R. E. GINNA NUCLEAR POWER PLANT

AMENDMENT TO PROVISIONAL OPERATING LICENSE

Amendment No. 12  
License No. DPR-18

SAFETY EVALUATION BY THE OFFICE OF NUCLEAR REACTOR REGULATION  
SUPPORTING AMENDMENT NO. 12 TO PROVISIONAL OPERATING LICENSE NO. DPR-18

Figure 3.1-1 Reactor Coolant System Heatup Limitations Applicable for 10.6 Effective Full Power Years.  $T_{ERROR} = 10^{\circ}F$ ,  $P_{ERROR} = 60$  PSI

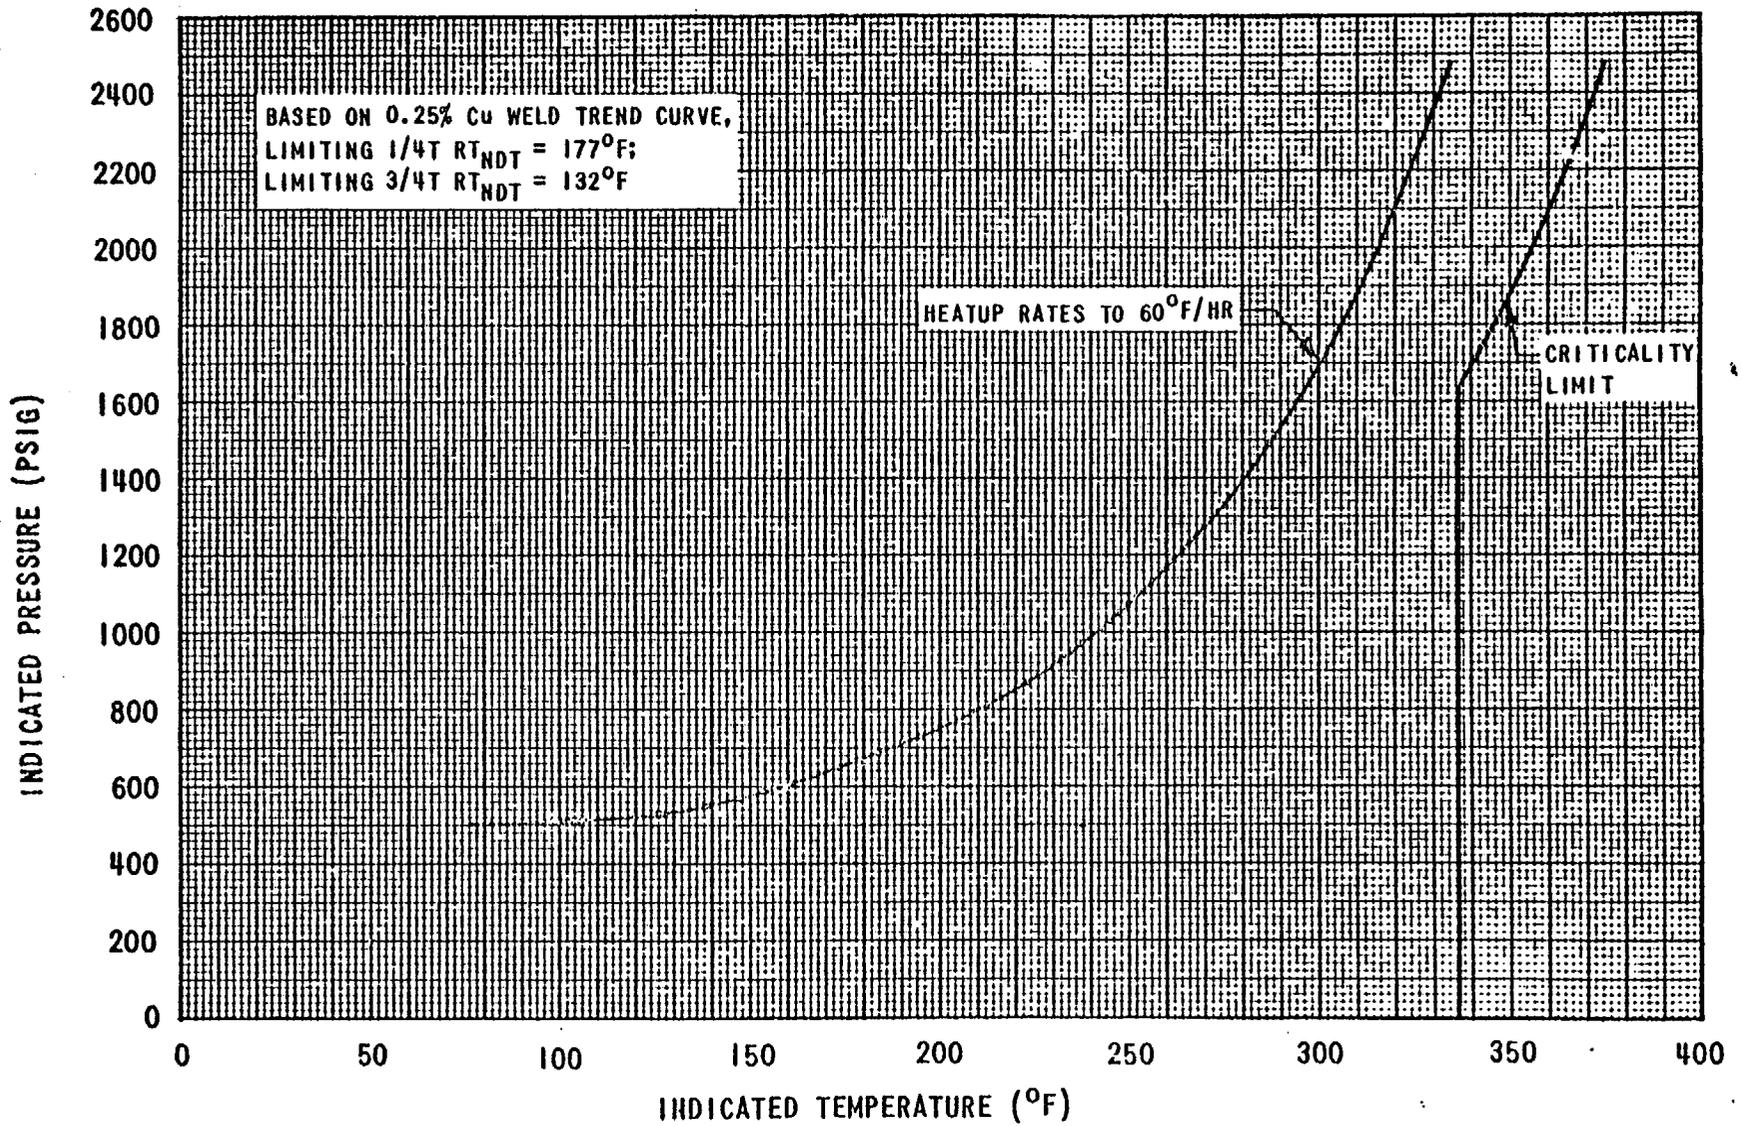
3.1.2.1 The reactor coolant temperature and pressure and system heatup and cooldown rates (with the exception of the pressurizer) shall be limited in accordance with Figures 3.1-1 and 3.1-2 for the first 10.6 effective full power years.

- a. Allowable combinations of pressure and temperature for specific temperature change rates are below and to the right of the limit lines shown. The heatup and cooldown rates shall not exceed 60°F/hr and 100°F/hr, respectively. Limit lines for cooldown rates between those presented may be obtained by interpolation.
- b. Figures 3.1-1 and 3.1-2 define limits to assure prevention of non-ductile failure only. The limit lines shown in Figures 3.1-1 and 3.1-2 shall be recalculated periodically using methods discussed in the Basis Section.

The heatup and cooldown pressure-temperature operating limitations for 10.6 EFPY proposed by RG&E are acceptable.

Figure 3.1-2 Reactor Coolant System Cooldown Limitations Applicable for 10.6 Effective Full Power Years. T<sub>ERROR</sub> = 10°F, P<sub>ERROR</sub> = 60 PSI

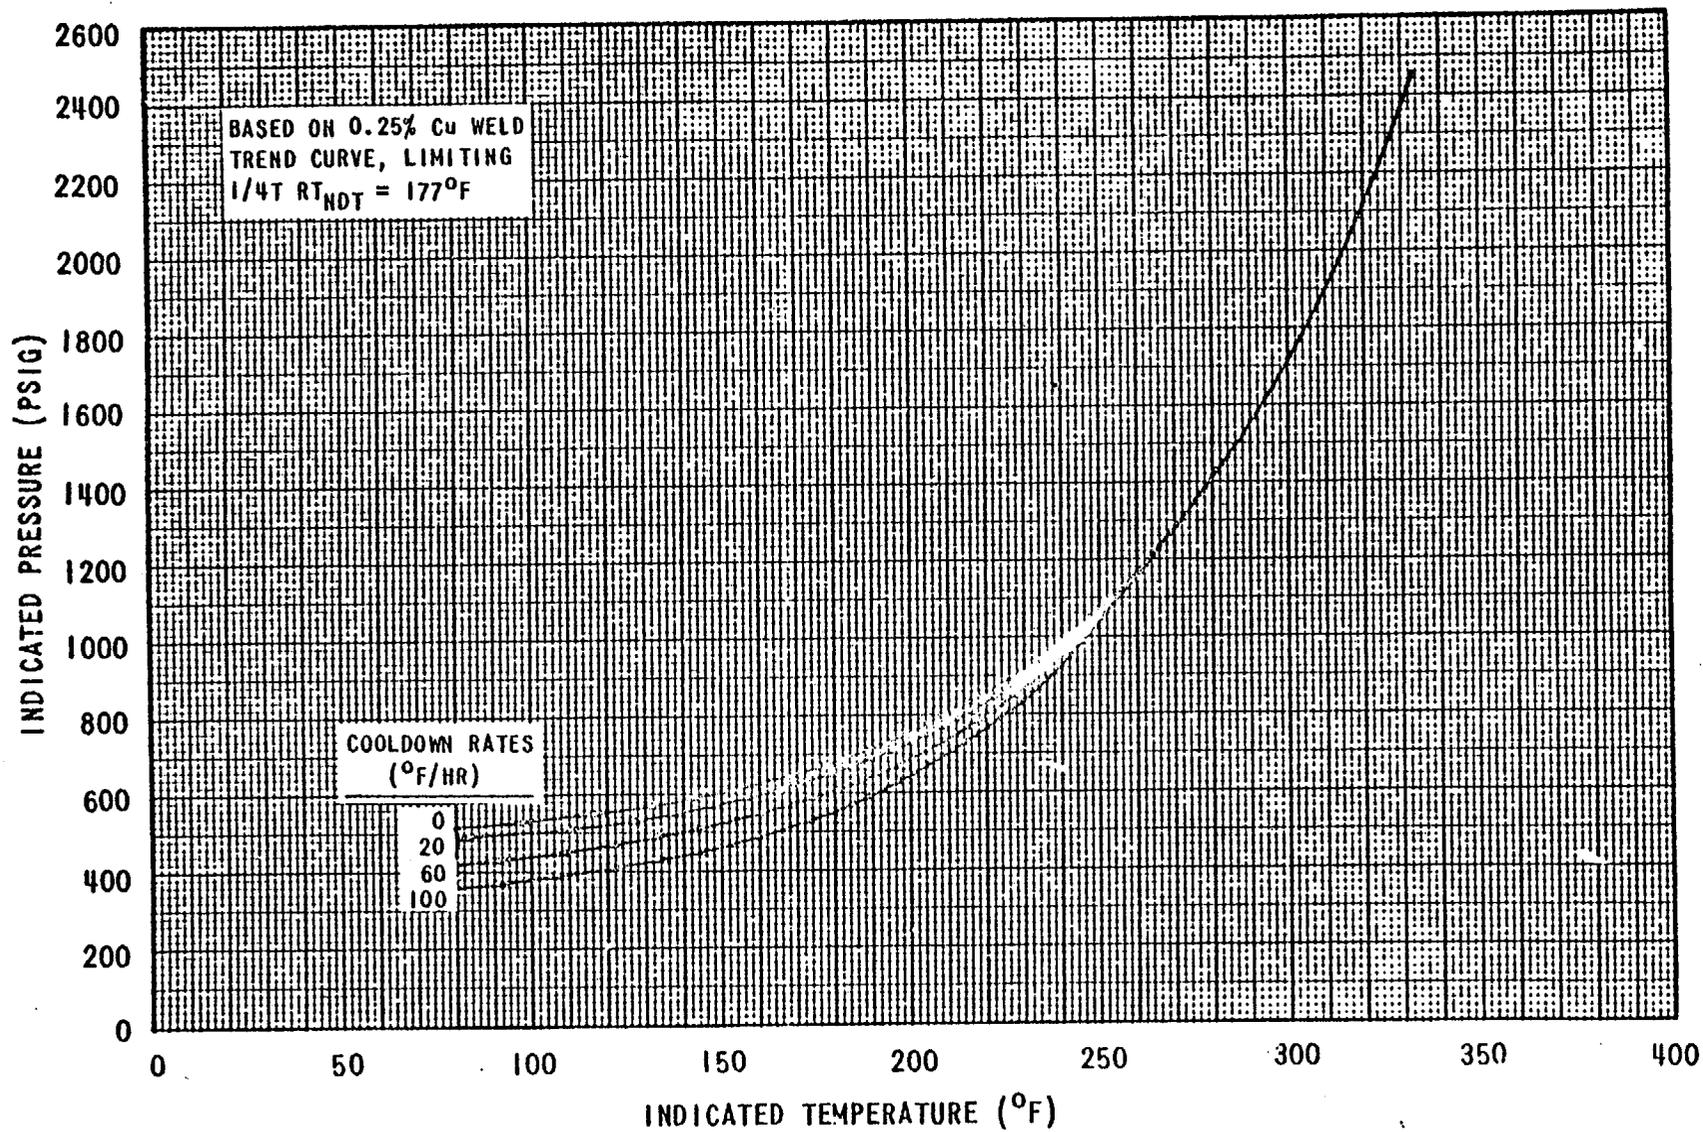
Because operation control is on coolant temperature and cooldown rate may vary during the cooldown transient, the limit curves shown in Figure 3.1-2 represent a composite curve consisting of the more conservative values calculated for steady state and the specific cooling rate shown.

Figure 6.2-7

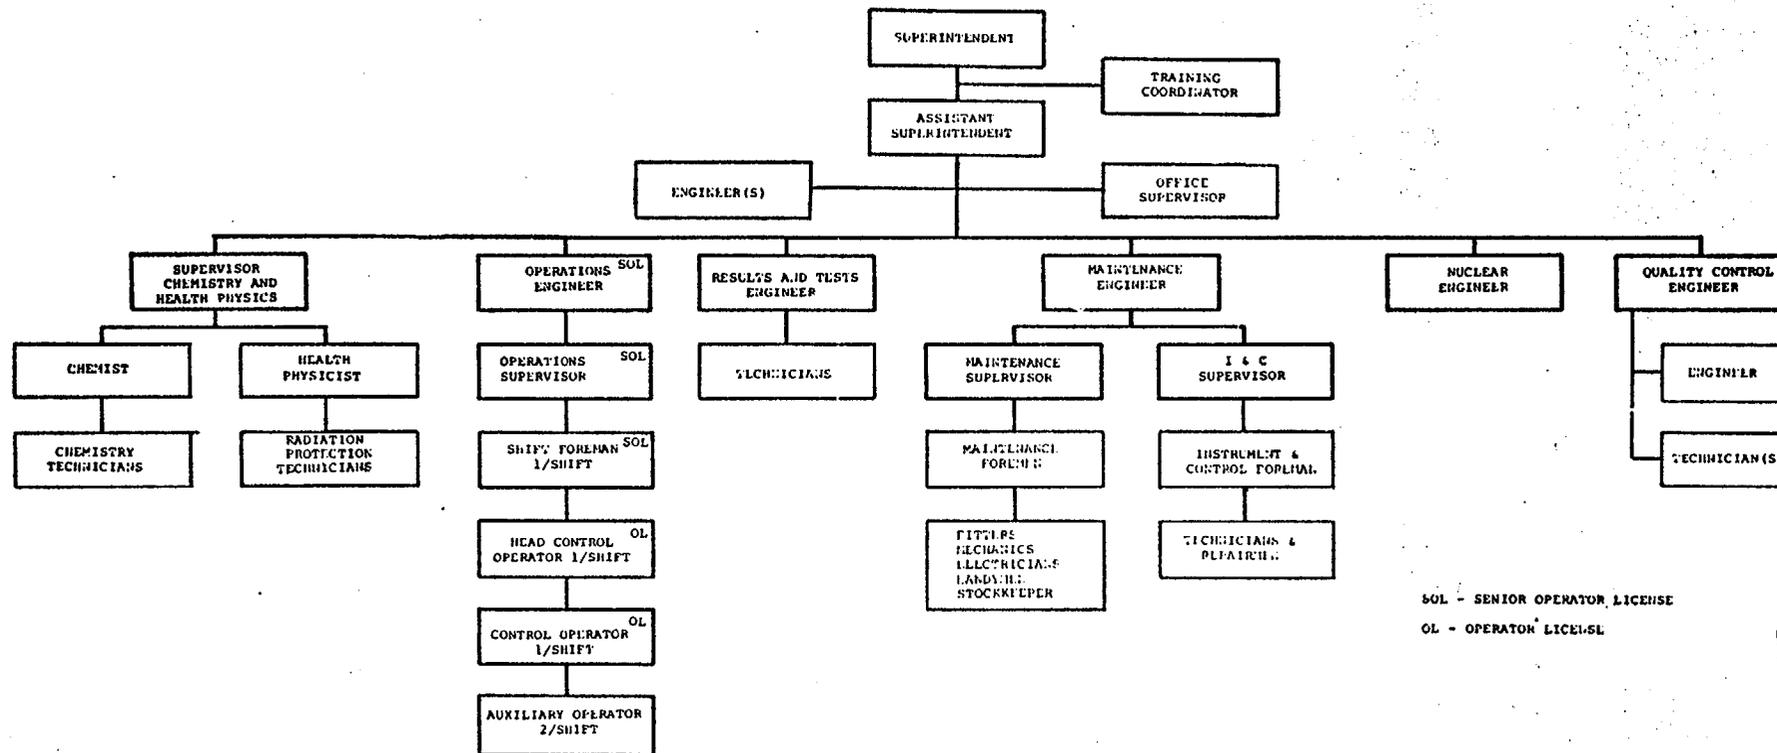
The Organization Charts in the Technical Specifications have been expanded to show the different groups within the corporate divisions associated with the operation of Ginna and to show more detail in the plant staff organization in the areas of technical and maintenance personnel. This change is purely administrative in nature, does not degrade RG&E's management control and is acceptable.
